Two Piece Closet Travel Latch

April 5, 2024

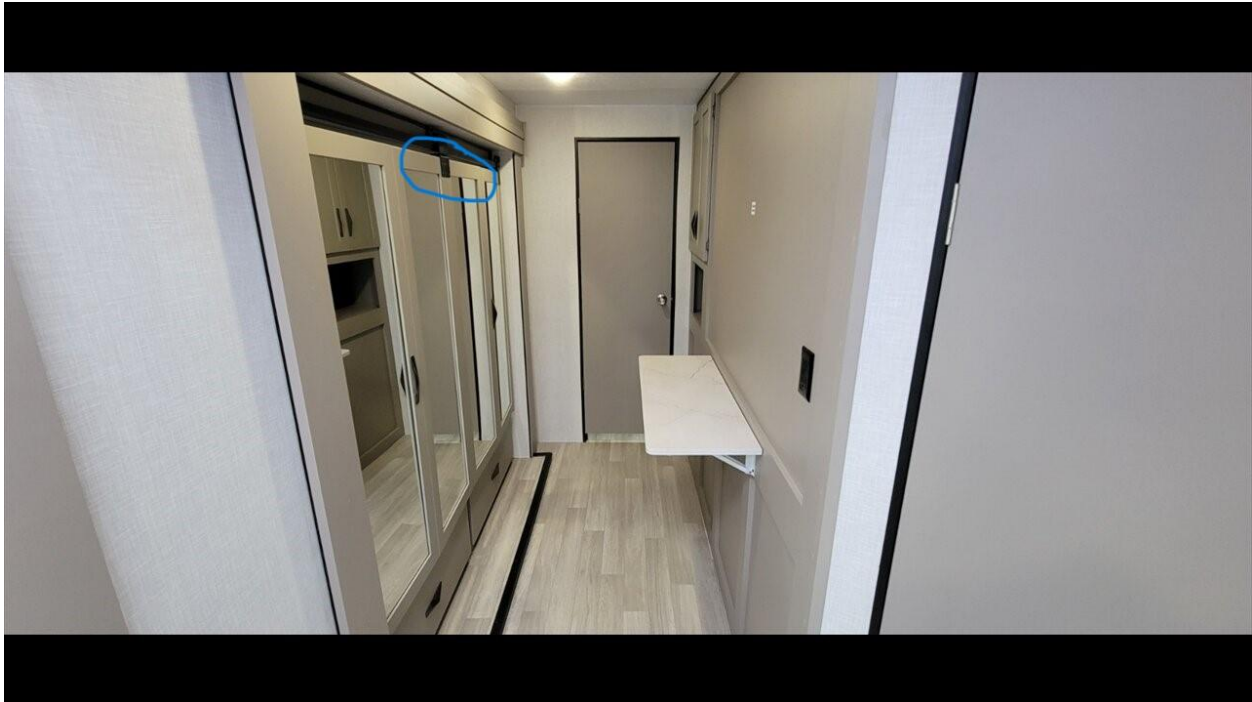
On this new floor plan KZ Connect C312 BRK the bunk room has barn style doors with no way to secure or latch them. They will not stay closed during transport. The black bracket has a magnet to hold the doors together, but it's not strong enough to keep them closed.

Add a two piece travel latch to secure the doors during travel. See attached picture.

Travel latches will be sent to your dealership and a claim can be made for the installation.
